**2. 1 WATERMARK DEVELOPMENT Block 11B Parcels 67 and 68 (F18-0221)
(P18-0534) (\$177.5 million) (JP)**

Application for fifty four (54) apartments, twelve (12) swimming pools, generator, signage and one 3-storey building containing a restaurant, spa, fitness centre, owners storage, manager's apartment and nineteen (19) guest suites with a connecting pedestrian bridge between the two proposed buildings over West Bay Road

Figure 1 – Beach ridge of block 11B parcel 67

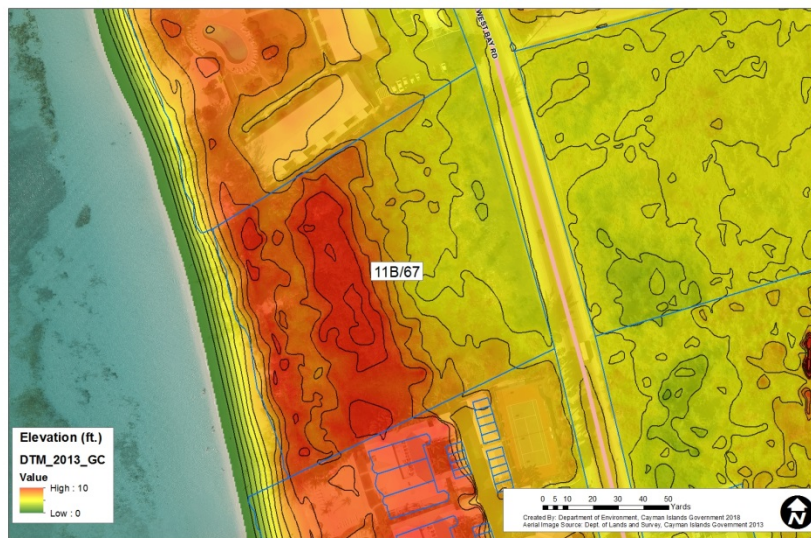
The removal of the beach ridge is a major concern. Seven Mile Beach is an extremely active beach system and the seaside parcel consists of massive sand reserves (see figure 1 below). These reserves are important to the resilience of the Seven Mile Beach system and are naturally used to replenish the beach after storms. The amount of sand that will result from the excavation for the pools, foundations and underground parking will likely be too great a quantity to be placed back on-site and into the beach system. Once excavated and removed from the beach system, these sand reserves can never be recovered, making the beach system increasingly more vulnerable to erosion. The solution to this is to increase the setback and leave the ridge intact.

- *Any sand that is to be excavated during construction should be retained on site and beach quality sand should be put back along the active beach profile of the property. If there is an excessive quantity of sand that cannot be accommodated on the site, and the applicant would like to move such sand offsite, it should be the subject of a separate consultation with the NCC.*
